MILITARY SPECIFICATION

MODULES, STANDARD ELECTRONIC

SHIFT REGISTER, DIGITAL, KEY CODE CHF

This amendment forms a part of MIL-M-28787/71C(EC), dated 9 September 1982, and is approved for use within the Space and Naval Warfare Systems Command, Department of the Navy, and is available for use by all Departments and Agencies of the Department of Defense.

FIGURE 42. Noise sensitivity test circuit waveforms for table XXVI.

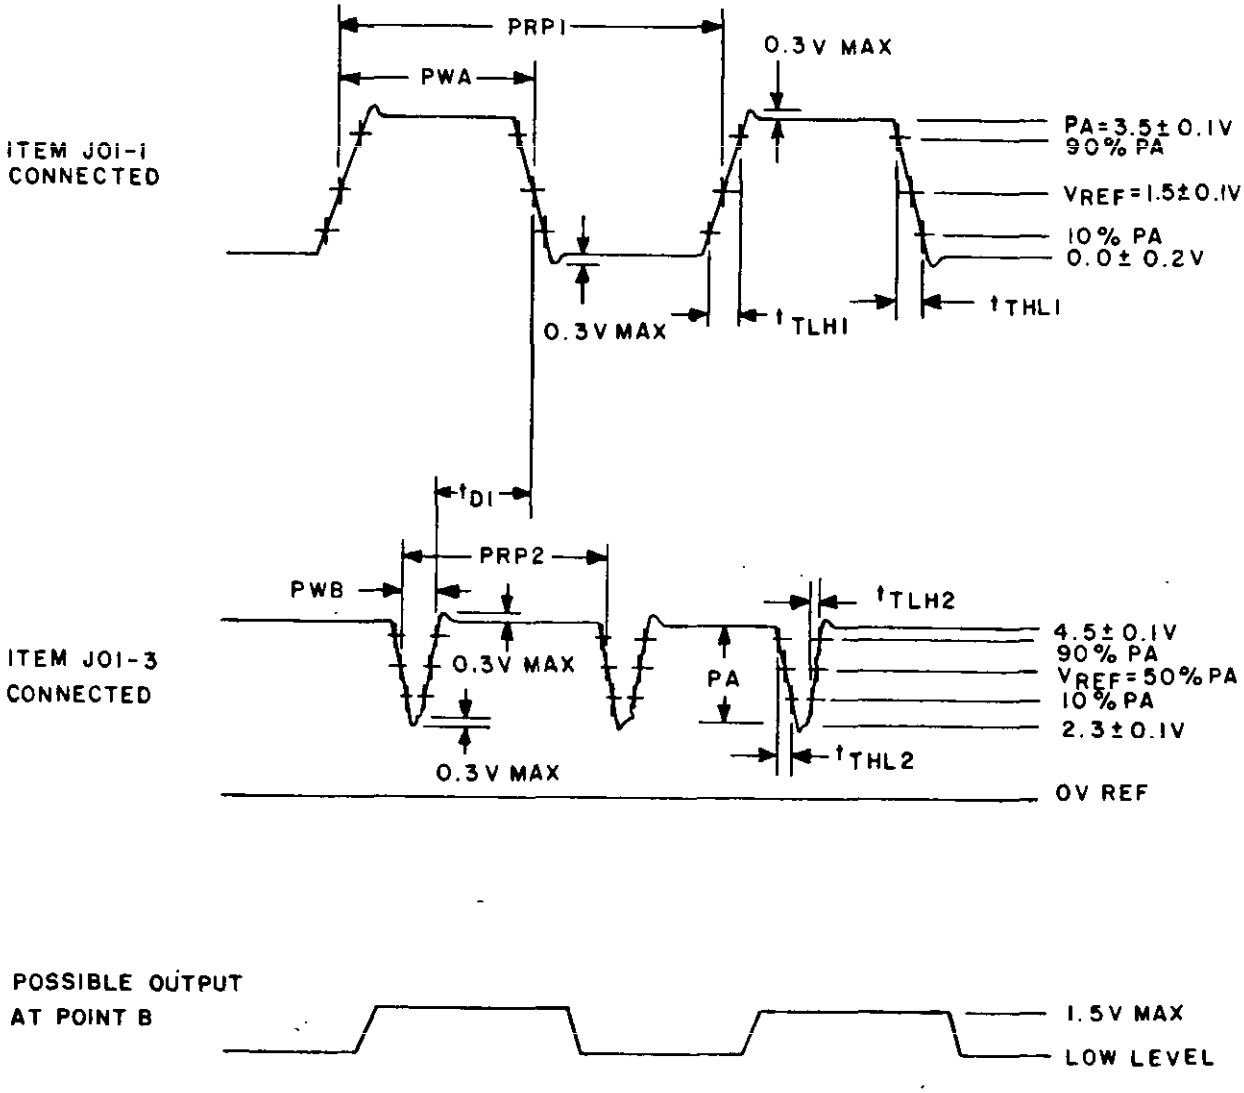
* FIGURE 41, NOTES: Delete notes 3 and 4 and add the following new tests:

* Following figure 41, add new figure 42 as printed on page 3 of this amendment.

"3. Item J01-3 pulse parameters for test conditions AA1-AA16:
PRP3 = 1000 ±100 ns.
PWC = 25 ±2 ns.
$t_{TLH3} = T_{THL3}$ = 6 ±2 ns.

4. Item J01-3 pulse parameters for test conditions AA17-AA48:
PRP3 = 1000 ±100 ns.
PWC = 30 ± 2 ns.
$t_{TLH3} = t_{THL3}$ = 6 ±2 ns.

5. Sweep the item J01-3 pulse through one cycle. The output pulse at point B shall meet the requirements of table XXVI (test conditons AA1-AA48)."

NOTES:
1. Item J01-1 pulse parameters:
   PRP1 = 1000 ±100 ns.
   PWA = 500 ±50 ns.
   $t_{TLH1} = t_{THL1}$ = 10 ±2 ns.
   t_{D1} = 100 ±10 ns.
2. Item J01-3 pulse parameters:
   PRP2 = 500 ±100 ns.
   PWB = 20 ±5 ns.
   $t_{TLH2} = t_{THL2}$ = 6 ±2 ns.
3. The output pulse at point B shall meet the requirements of table XXVI (test conditions AA49-AA64).
